ABBREVIATED PLAT AGENDA

August 27, 2025

STAFF REVIEW AND RECOMMENDATIONS
PUBLIC HEARING
AUGUST 27, 2025

ABBREVIATED PLAT: GILCA'S GLADE LOTS 1A & 2A
LEGAL DESCRIPTION: SEC 35, T17N, R02W S.M., AK
PETITIONERS: EUGENIU GILCA
SURVEYOR/ENGINEER: HANSON LAND SOLUTIONS/BILL KLEBESADEL
ACRES: 6.21 +/- PARCELS: 2
REVIEWED BY: CHRIS CURLIN CASE #: 2024-104

A SUBDIVISION OF
FISHHOOK AIRSTREAM LOT 1
(2025-27)

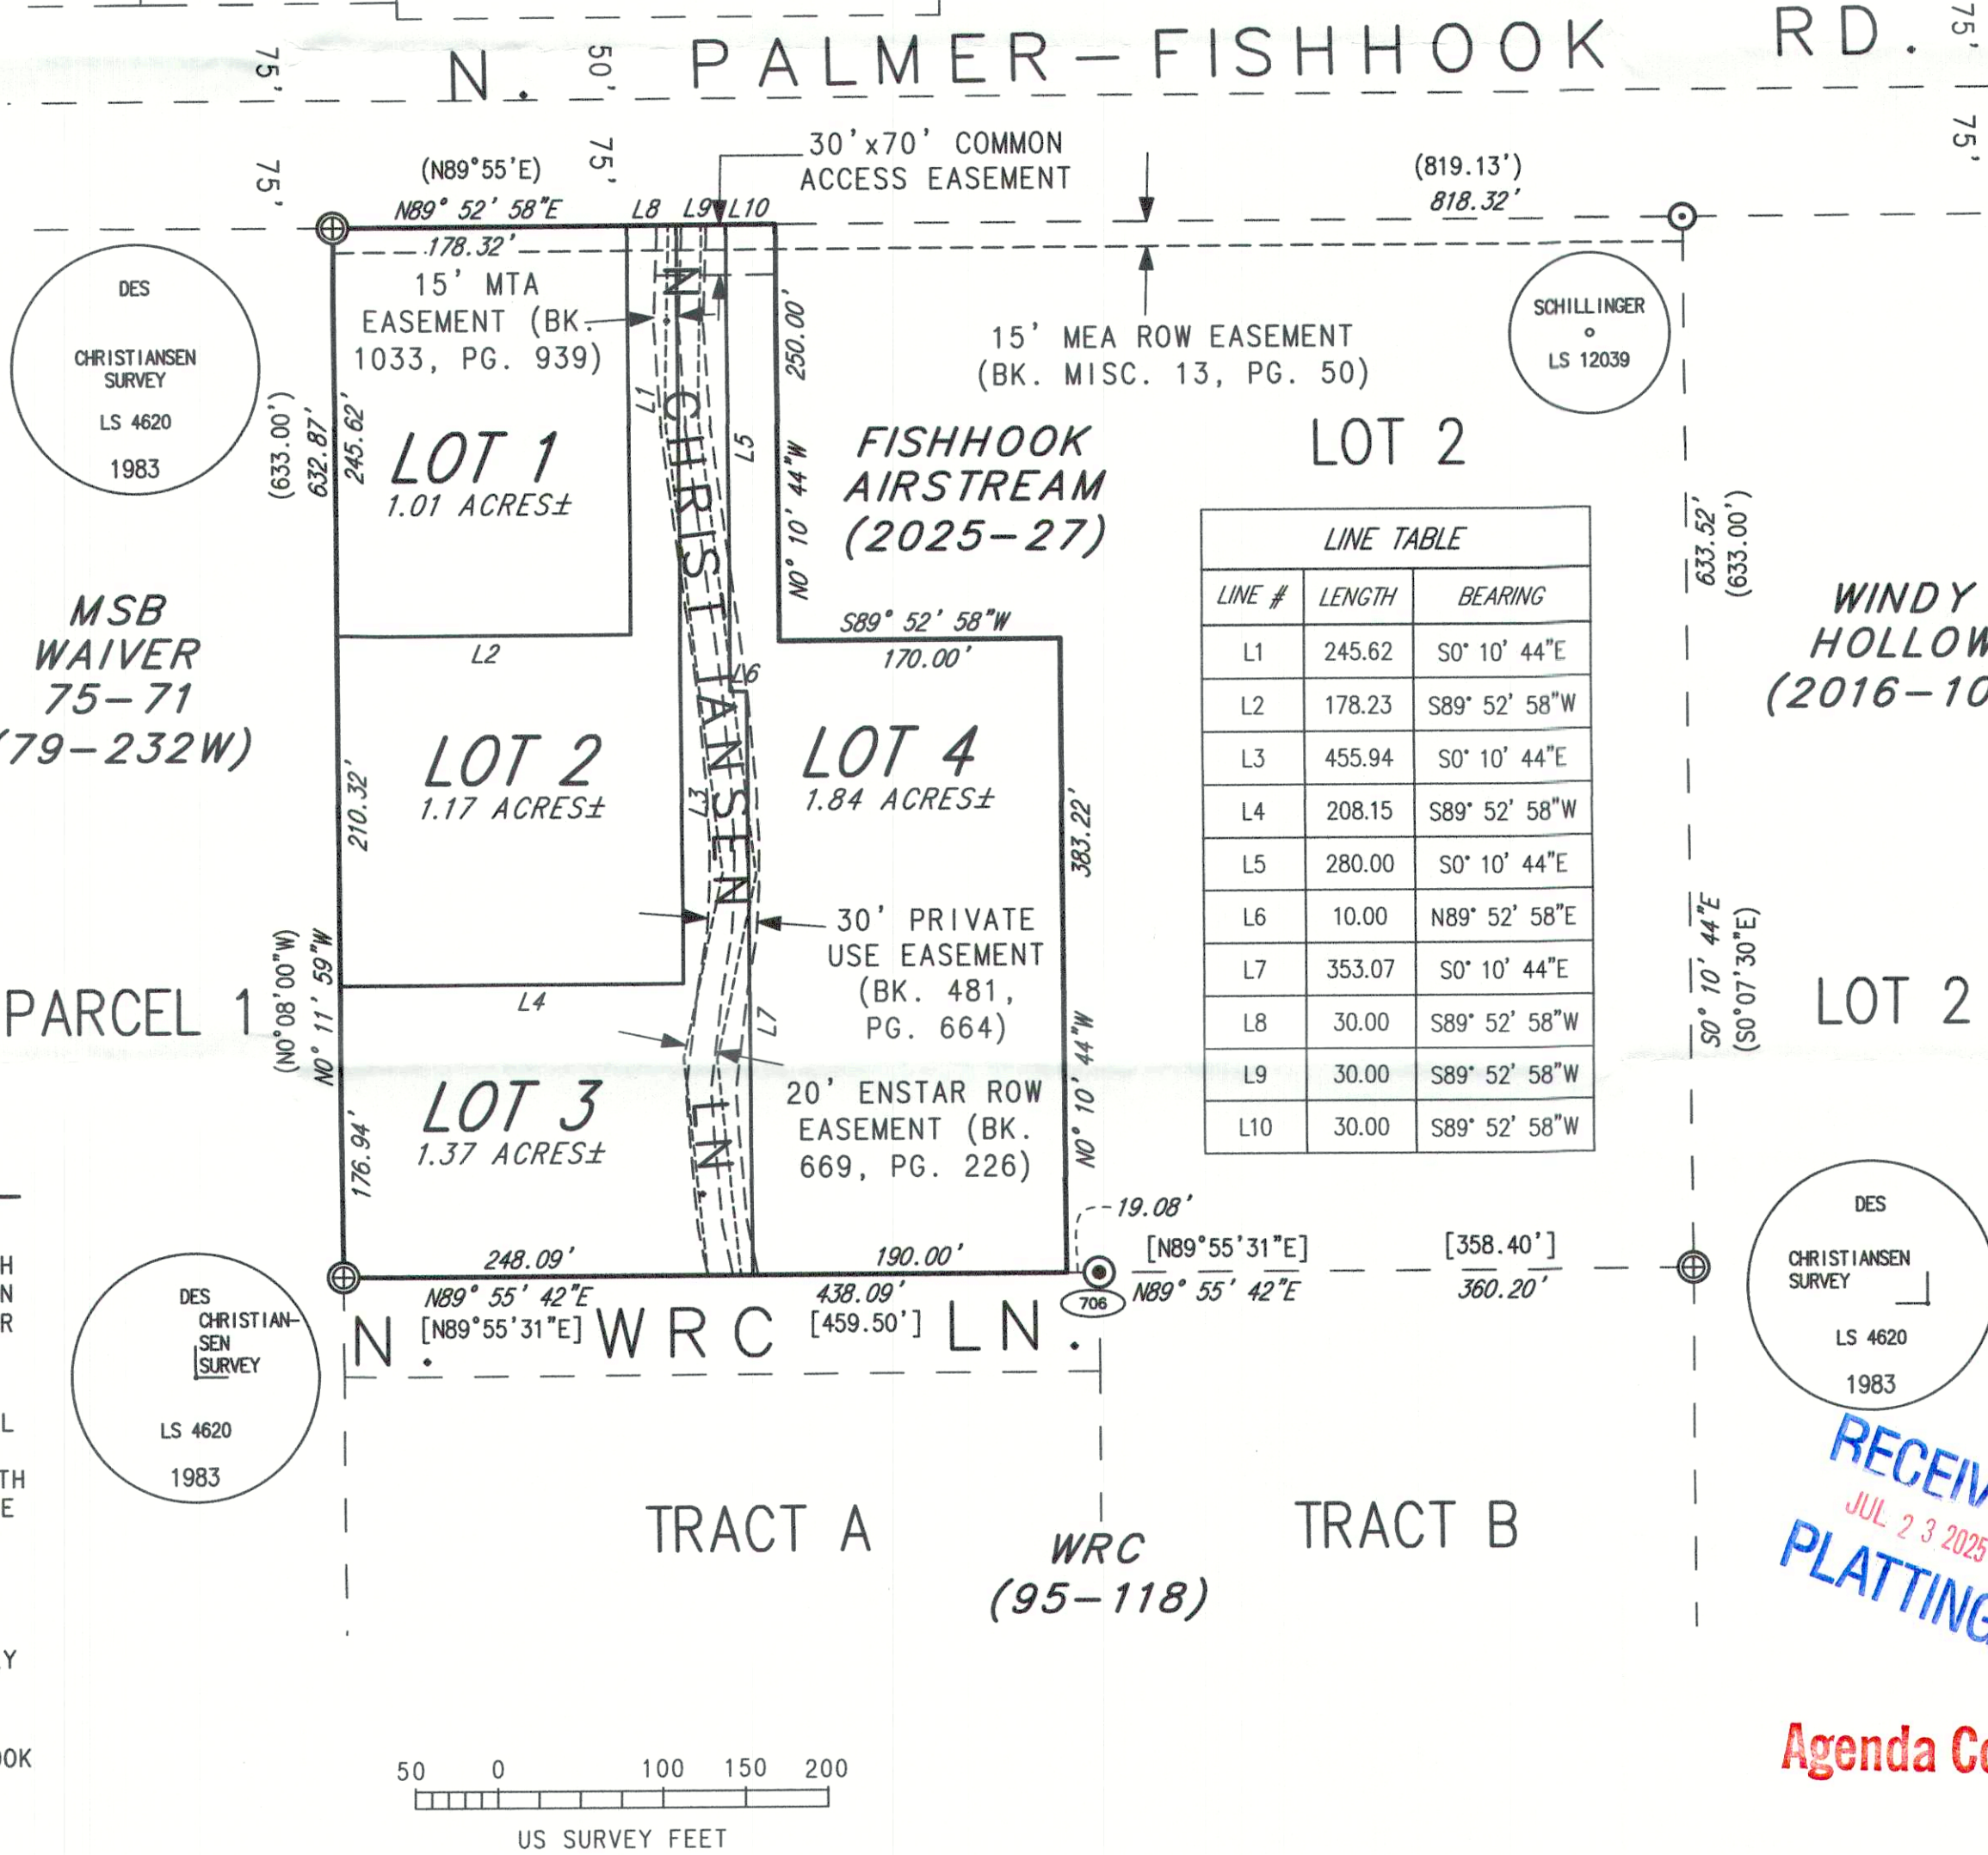
ADOT&PF (**Exhibit C**) Add plat note: “No direct access for all lots to Palmer-Fishhook Road.”

The soils report and test hole logs are not signed by the engineer. Please resubmit.

Note 5 on the plat should be revised to state all lots should take access to Palmer-Fishhook from Christiansen Lane.

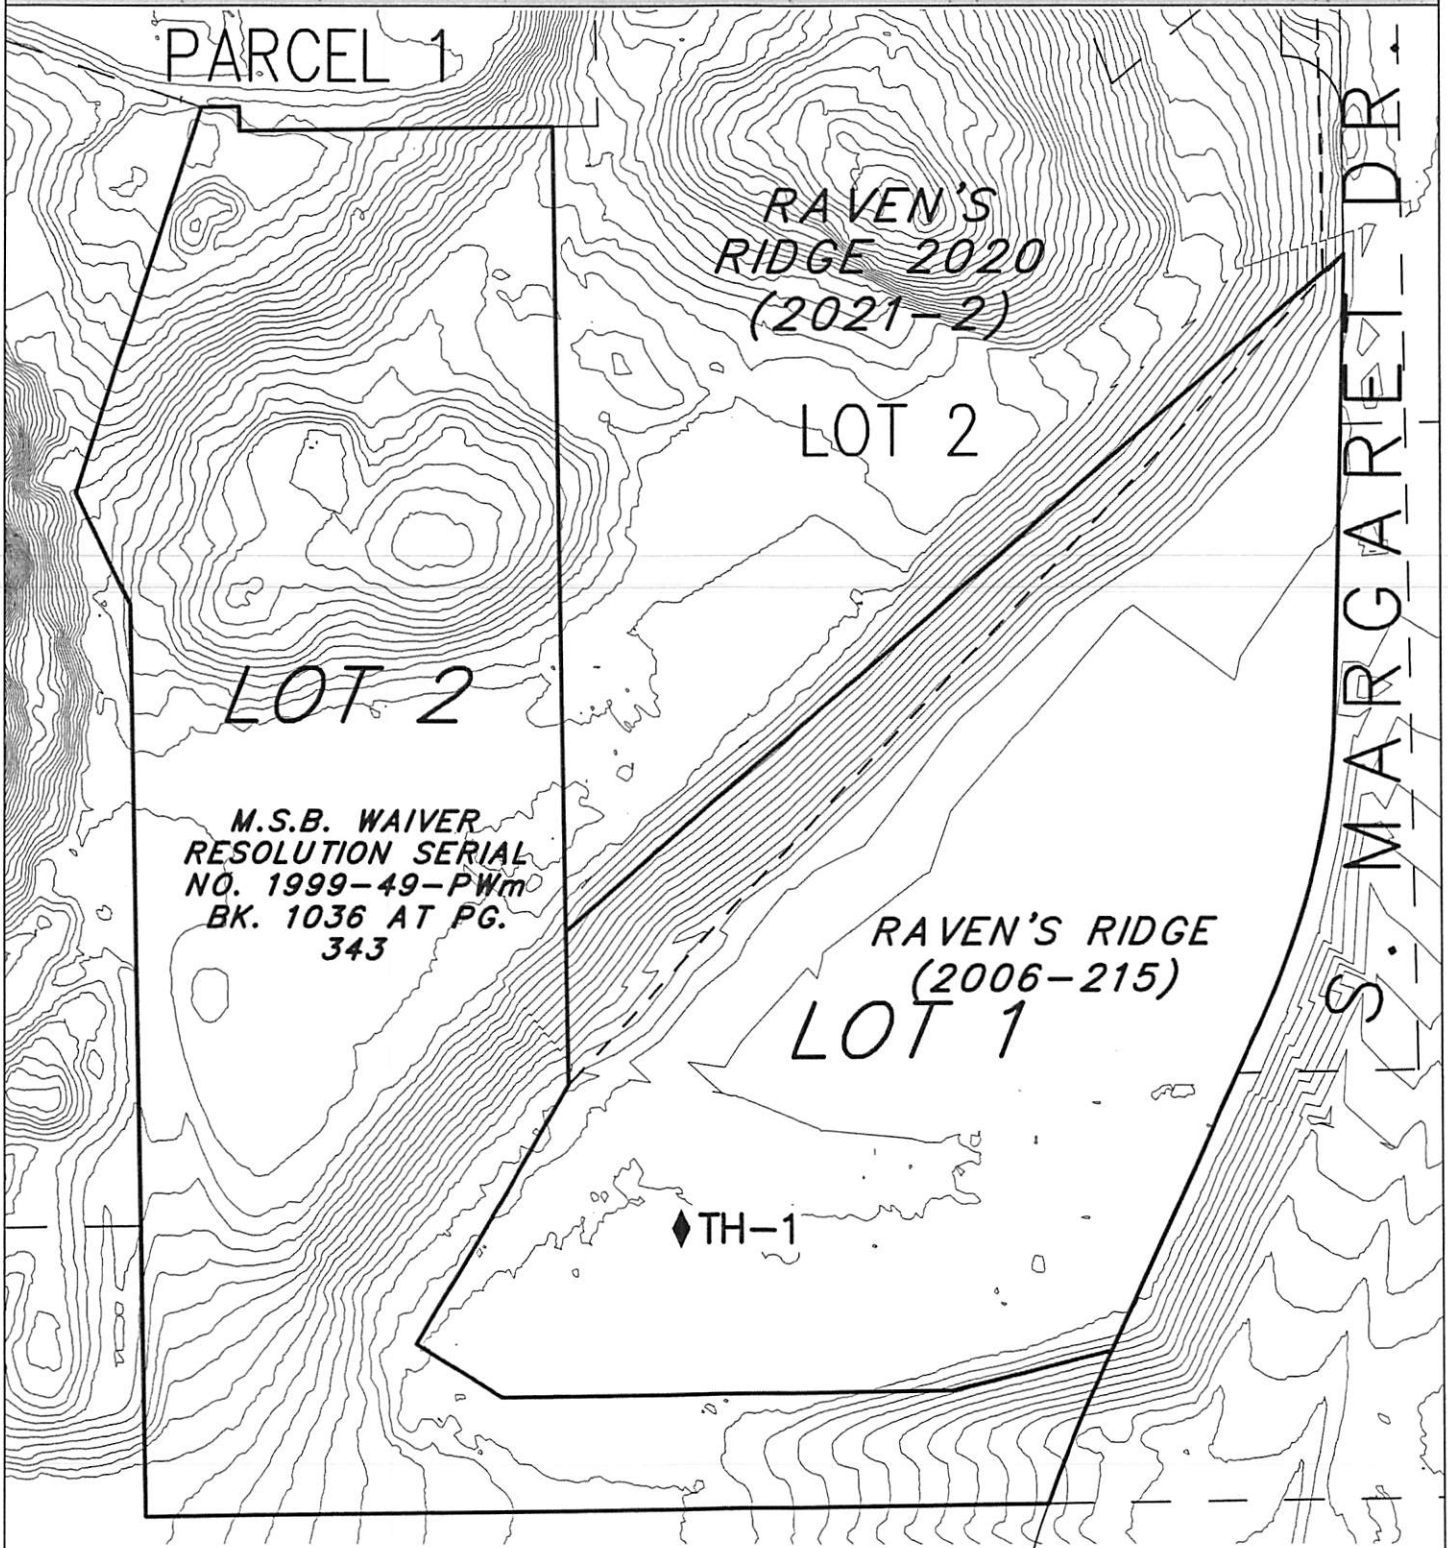
Because of the topography and difference in elevation between the two lots, test hole 1 is not representative of the soils on lot 2. Please provide additional information.

Because of the topography and difference in elevation between the two lots, test hole 1 is not representative of the soils on lot 2. Please provide additional information.

Based on comments received from DPW PD&E (see below) it was noted that a revised soils report with an additional test hole is needed.
